SERVICE Counselor

PACKARD MOTOR CAR COMPANY

FEBRUARY, 1952

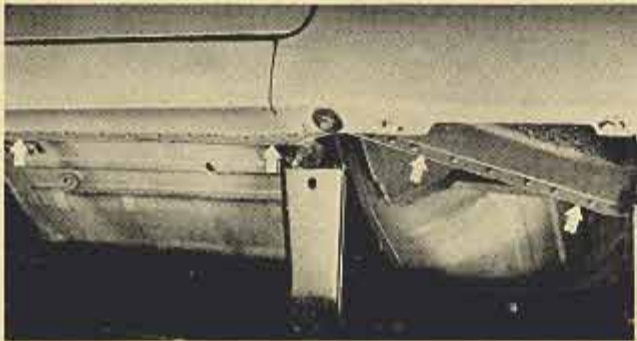
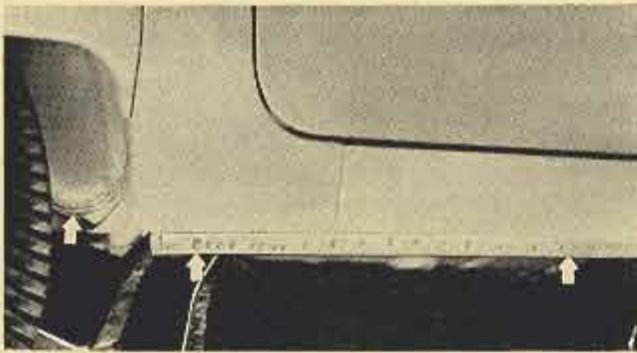
In a few instances it was found that the side sill panels and body panels were not properly welded to the floor panel or that the welds were broken.

The arrows in the two illustrations show the location of the welds.

When a body shake condition exists, the welds should be inspected for number of welds and spacing between welds, which is approximately $1\frac{1}{2}$ ". A feeler gauge or a thin bladed screwdriver can be inserted between the panel flanges to check for broken welds.

The rewelding operation can be accomplished by clamping the panel edges together with vise grip pliers and then spot welding the lower edges of the panels each side of the pliers. Continue this operation wherever welding is necessary. The welding can be done with either an electric arc welder or an acetylene torch.

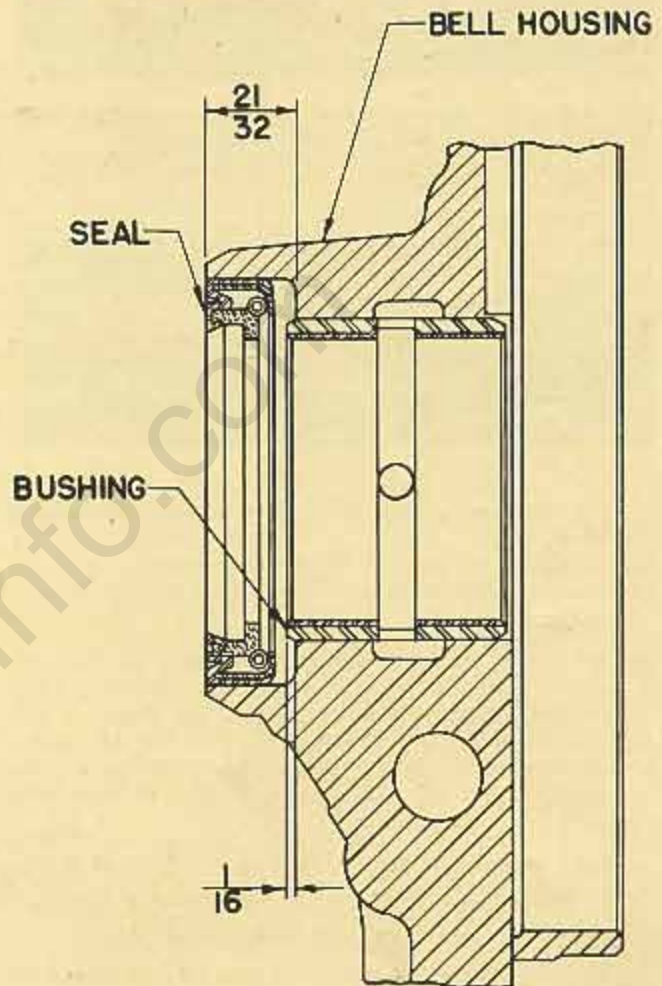
Reverse gear jump-out has been reported on a few 23rd Series cars when equipped with R-11 overdrive and 24th Series overdrive equipped cars, but has only been found where the reverse operation was for long distances.

It was generally found that when in reverse gear, the first and reverse shift fork detent ball was not fully engaged in the detent groove because of insufficient overtravel; therefore, the spring on the overdrive shift rail would work the reverse gear out of mesh. This correction has been made in production.

- (a) Disconnect the low and reverse shifter rod from the lever at the transmission.
- (b) Move the lever to the rear as far as it will go.
- (c) Release the lever and it should jump forward a slight amount.

If the detent does not fully engage as described, disassemble the overdrive assembly far enough to remove the reverse plunger, shift rail and fork. Grind .030" off the forward end of the plunger. This is the end that contacts the reverse shift fork pad in the transmission. The extra clearance will allow the shift fork to move further toward the rear and the detent to fully engage. Please refer to your Service Manual on page 7, figure 16, transmission and overdrive section for illustration of the reverse plunger.
